BULLETIN # 196

SYNCHROPULSE CDT450, CP38 WITH W37

WIRE DRIVE SPEED IRREGULARITY

Fig 1, CP38-52 Circuit Showing Addition of D7

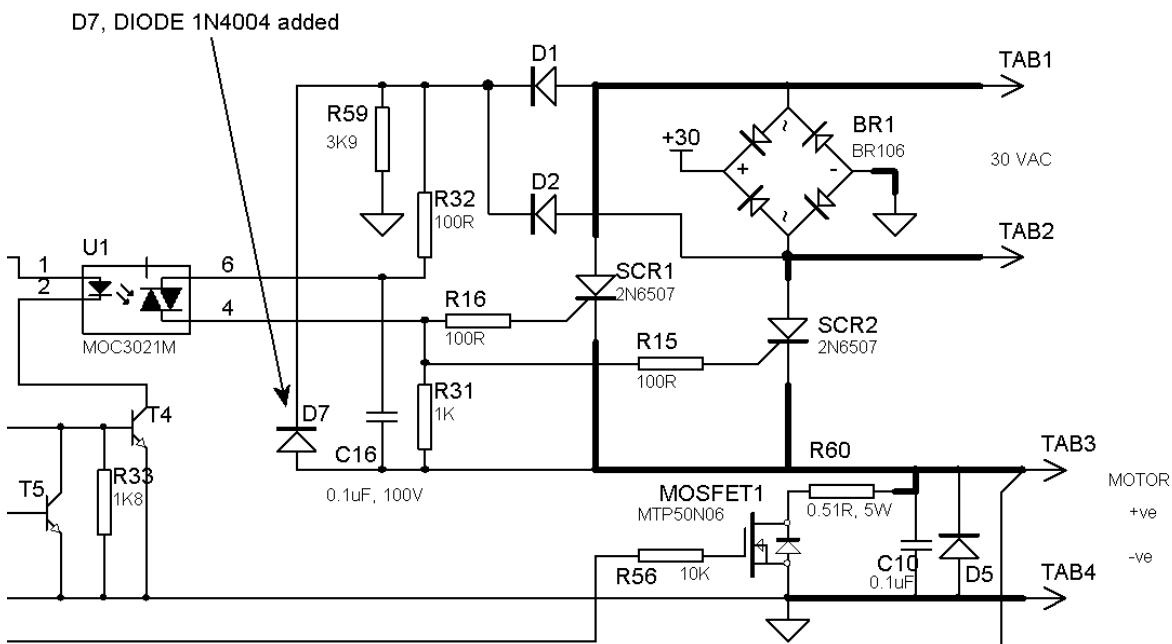
There have been some instances reported recently where the wire drive suffers from inconsistent speed. This problem has been traced to electrical noise which may be generated by the wire drive motor used on the W37 wirefeeder. This electrical noise can disrupt the speed control system of the CP38-52 wire/gas board, causing speed irregularity. The following circuit and instruction details a modification which prevents any noise of this type from causing speed irregularities.

A 1N4004 diode has been added to the CP38-52 pcb. Fig 1 shows the location of D7 in the CP38-52 circuit, and Fig 2 shows where D7 is located on the solder side of the pcb. A suitable alternative to the 1N4004 diode would be 1N4005, 1N4006 or 1N4007.

All new CP38-52 pcb's will have this diode added, and be labelled as Issue C.

New CP38-3 machines starting from serial number CP383H0605163001 will have this modification.

Fig 2, Location of D7 on Solder Side of PCB

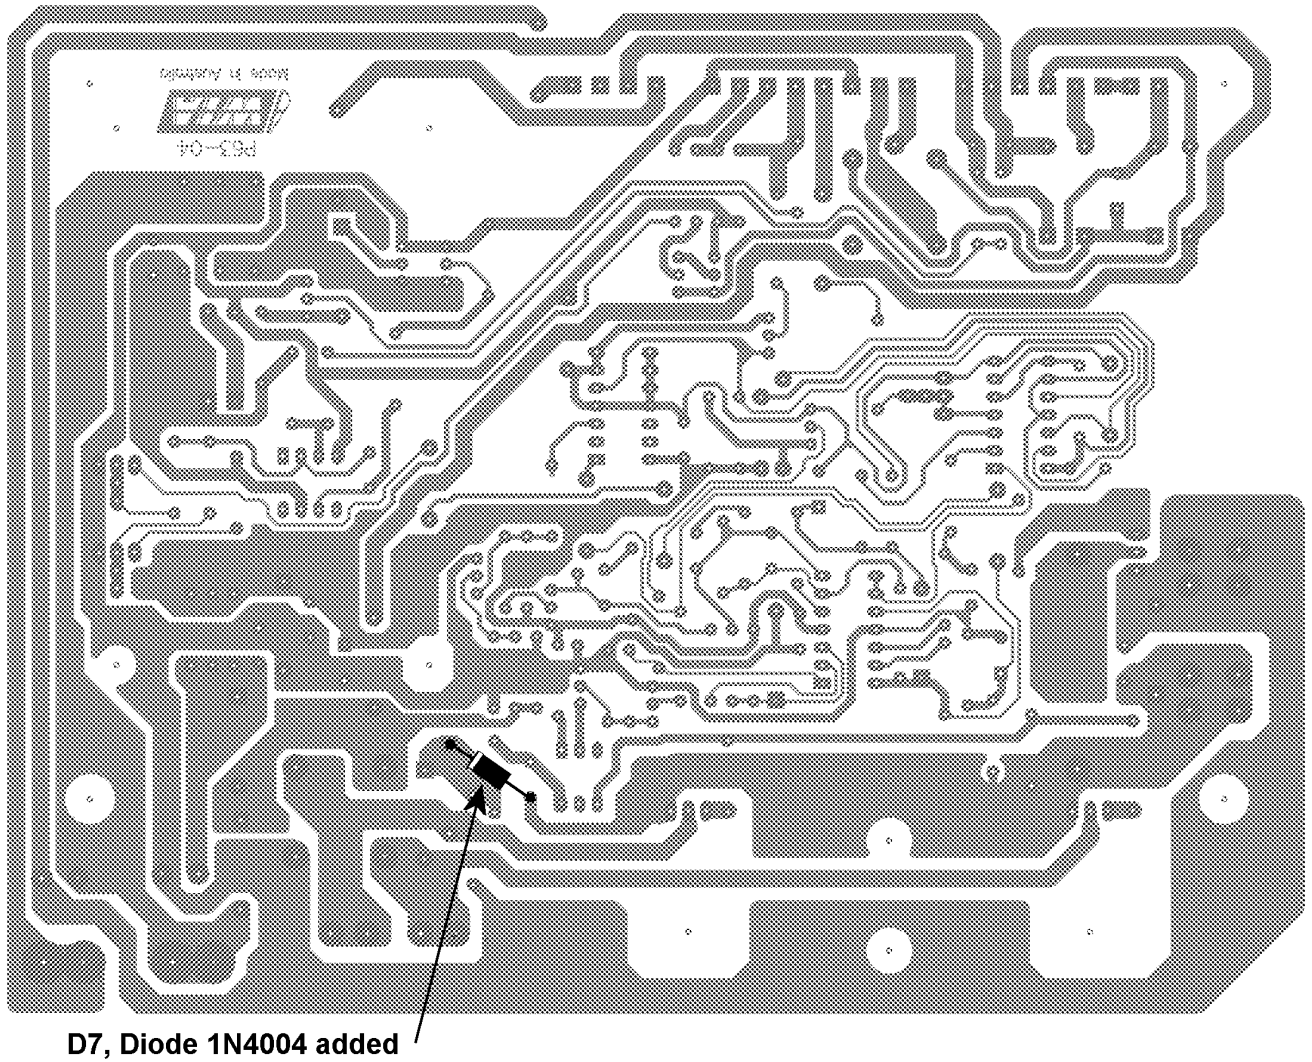
D7, Diode 1N4004 added
